UNITED STATES PATENT AND TRADEMARK OFFICE

Office Action Summary	Application No. 10/560,612	Applicant(s) CLYMANS, ETIENNE	
	Examiner MAI T. NGUYEN	Art Unit 3671

DETAILED ACTION

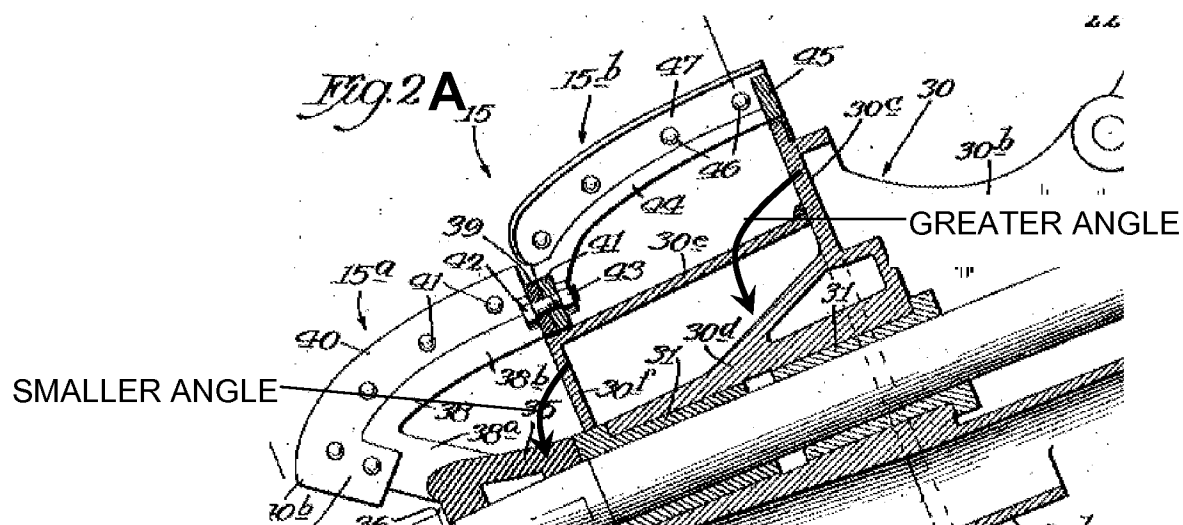
Regarding claims 5 and 12-14, Neveling discloses the device wherein the cutter shield 39, 45 takes the form at the bottom of a truncated cone in the direction of the cutter head 15a, 15b, wherein the smaller support ring diameter 39 of the cutter head 15a has an opening of the truncated cone having a greater angle than the angle of the opening of the greater support ring diameter 45 of the cutter head 15b, see following fig. 2A.
